SUBJECT: First Five-Year Review Report  
Piper Aircraft Superfund Site  
Vero Beach, Indian River County, Florida

**First Five-Year Review Report for  
PIPER AIRCRAFT NPL SITE  
The New Piper Aircraft, Inc.  
Vero Beach, Indian River County, Florida**

**December 2003**

Thank you for your submittal of the First Five-Year Review Report (DRAFT). EPA and FDEP have reviewed the document and submit the following comments. The Five-Year Review process is intended, in part, to evaluate the protectiveness of the selected remedial action. According to the details in the report, EPA feels that modifications to the remedial action should be considered by Piper because the UVB wells do not appear to be operating properly and adjustments could be made in the location and monitoring of the monitoring wells to improve the systems efficiency. Please view this comment letter in two respects: First, comments on the report itself (listed mostly in Section 1.) should be addressed so the that the report can be finalized and approved by EPA. Second, comments concerning the potential modifications to the remedial action (Sections 2. through 5.) should be considered in any future work at the site. EPA r

**FIGURE 20**  
 MODELED  
 GROUND WATER  
 PIEZOMETRIC SURFACE  
 CITY WELL NO. 15  
 PUMPING AT 293 GPM

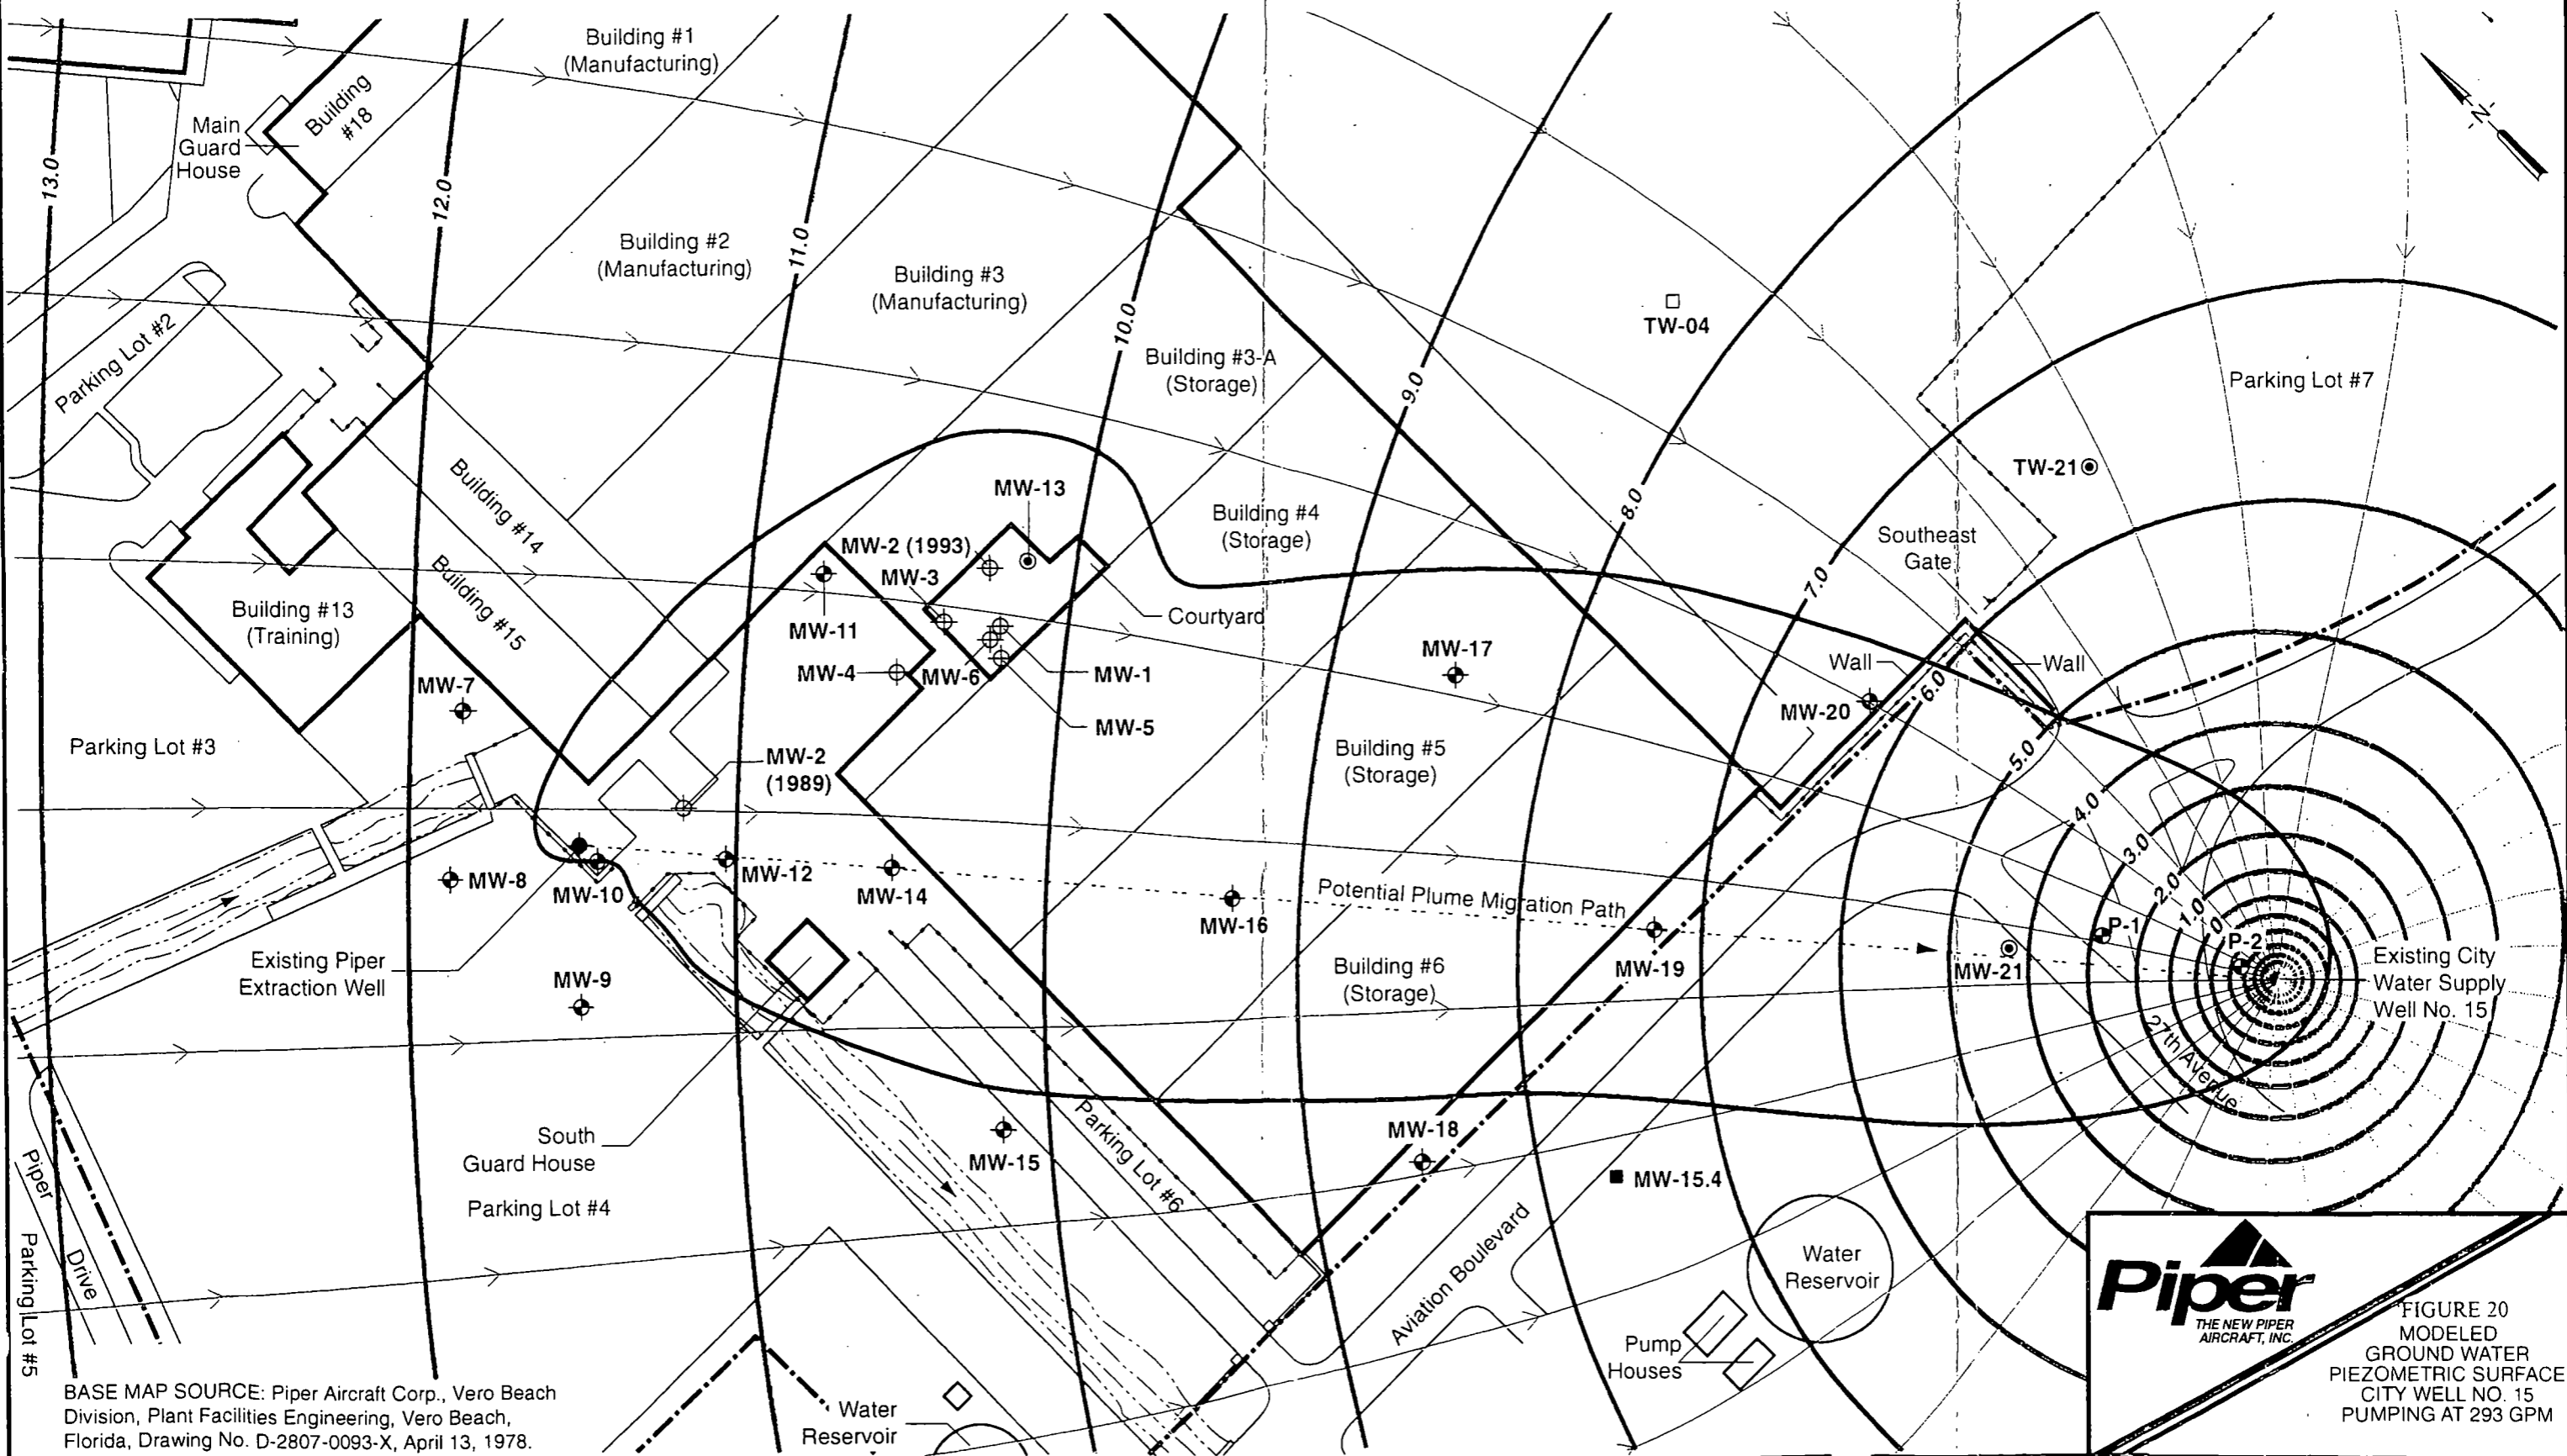
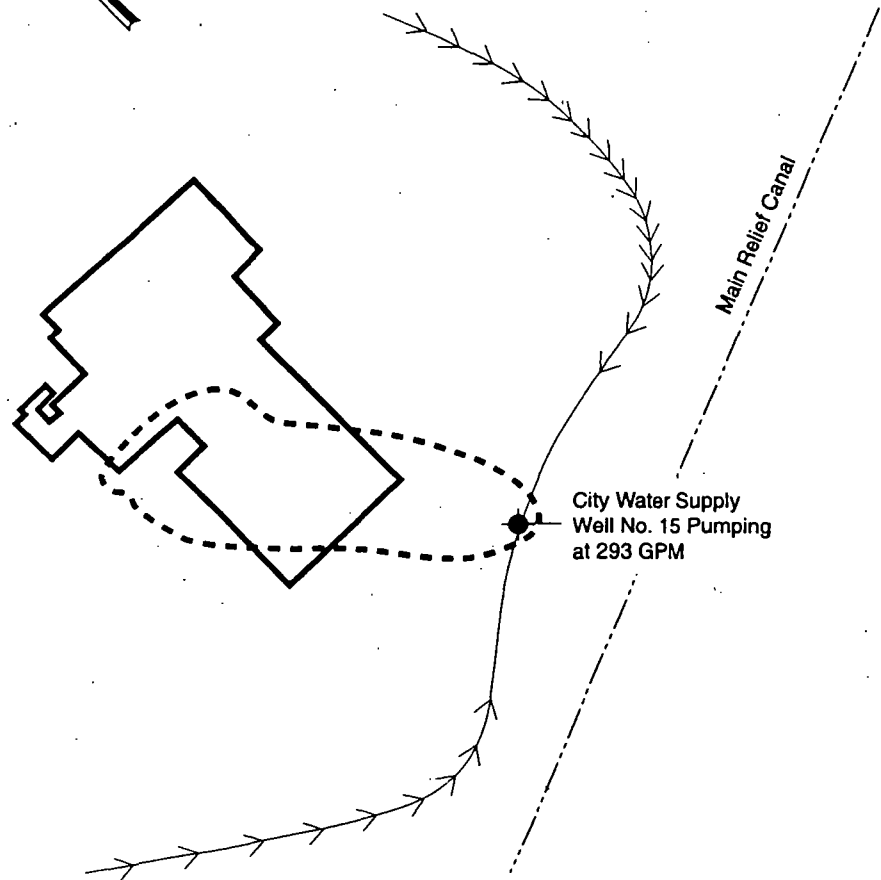
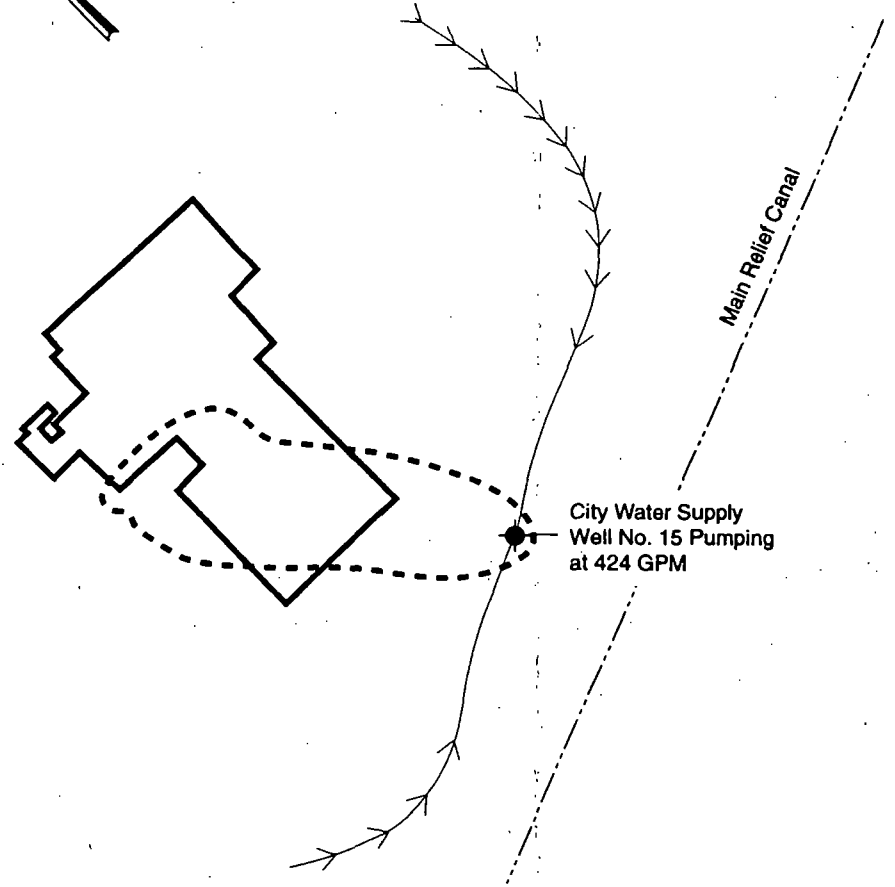
- 3.4 As previously noted, trends for wells in the down-gradient part of the plume have for the most part been undetectable, because of the extreme variability in concentrations over the period of record. There appears to be a large area of potential contamination in the downgradient part of the plume that is not being effectively monitored by any of the existing monitoring wells. This comment is based on the fact that some low levels of contamination have been detected at MW-18, and this well is some 200 feet distant from MW-19. The concern arises regarding what contaminants may be present in the area between these two wells. Figure 2 in the Five-Year Review Report depicts the contaminant plume as terminating at the Vero Beach water-supply well #15 (i.e. any contamination migrating past UVB-2 is eventually captured by the water-supply well). The basis for this interpretation appears to be supposition, or a conceptual model, rather than being confirmed by actual water-quality or water-level monitoring data. Whether or not the Vero Beach Well #15 is the ultimate sink for contaminated ground water that bypasses the UVB wells, the apparent minimal concentration decreases at the water-supply well over the time since the 1992-1993 RI are an indication that the remedy is not successfully containing contamination and is probably inefficient in remediation at least some of the contamination at this Site. FDEP made this same comment.

*Figure 21 illustrates modeling of CVB-Well #15 capture zone based upon a large-scale comprehensive pumping test conducted in 1997 and reported in submittals at that time. It is reasonable to conclude that CVB-Well #15 acts as a complete barrier to the movement of residual Vinyl Chloride past the well to the southeast EPA groundwater quality testing in 1992 and 1993 as reported in EPA Superfund Update of January 1995, concluded that: "The canal is acting as a hydraulic barrier preventing the contaminants from migrating to the south side of the canal (e.g., no VOC's were detected south of the canal)".*

*Figures 20 and 21 have been added to the Five Year Review Report to represent the best existing interpretation of the CVB Well 15 capture zone in the form of flow net modeling from data collected during pumping tests of CVB Well 15 with data collection from existing and former pumping test monitoring wells. These data were originally reported in Appendix K of the Supplemental Investigation And Focused Feasibility Study For Preliminary Remedial Design, March 20,1997.*
